Access Compliance Report

Public Rights-of-Way

(Curb Ramps)

Intersection ID: 10041624	Main Street: WHITEHALL_EXECUTIVE_CENTER_DR	Cross Street: N/A	Location: SE
ADA ID: A217DBB6CCB8	Ramp Type: Perp	Initial Pass/Fail: Fail	Overall Compliance: No
Severity Score: 17.5			
Codes/Mitigation Info/Possible Solution		Field Measurements/Component Compliance

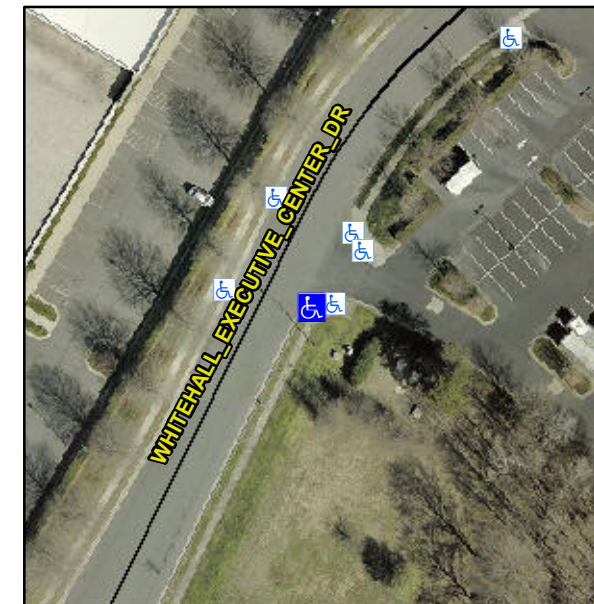
Not Found, R304.5.1

Compliance	Description	Data	Compliance	Description	Data
N/A	Ramp Length (in)	84.0	Yes	Ramp Slope (%)	6.4
No	Ramp Width (in)	33.0	Yes	Ramp XSlope (%)	0.9
N/A	Flare Type LT	N/A	N/A	Flare Type RT	N/A
N/A	Flare Slope LT (%)	N/A	N/A	Flare Slope RT (%)	N/A
N/A	Flare Traversable LT?	N/A	N/A	Flare Traversable RT?	N/A
N/A	Landing Length (in)	N/A	N/A	DWS Provided?	N/A
N/A	Landing Width (in)	N/A	N/A	DWS Contrast?	N/A
N/A	Landing Slope (%)	N/A	N/A	DWS Length (in)	N/A
N/A	Landing X Slope (%)	N/A	N/A	DWS Full Width?	N/A
N/A	Landing Curb? (Y/N)	N/A	N/A	DWS Offset (in)	N/A
N/A	Shared Landing?	N/A			
N/A	Gutter Ponding?	N/A	N/A	Gutter Slope (%)	N/A
N/A	Gutter Lip Ht (in)	N/A	N/A	Gutter X Slope (%)	N/A
N/A	Painted X Walk1?	No	N/A	Painted X Walk2?	N/A
	X Walk 1 Direction	To NW		X Walk 2 Direction	N/A
N/A	X Walk 1 Width (in)	N/A	N/A	X Walk 2 Width (in)	N/A
	X Walk 1 Slope (%)	4.5		X Walk 2 Slope (%)	N/A
	X Walk 1 X Slope (%)	2.4		X Walk 2 X Slope (%)	N/A

Remove & Replace Entire Ramp.
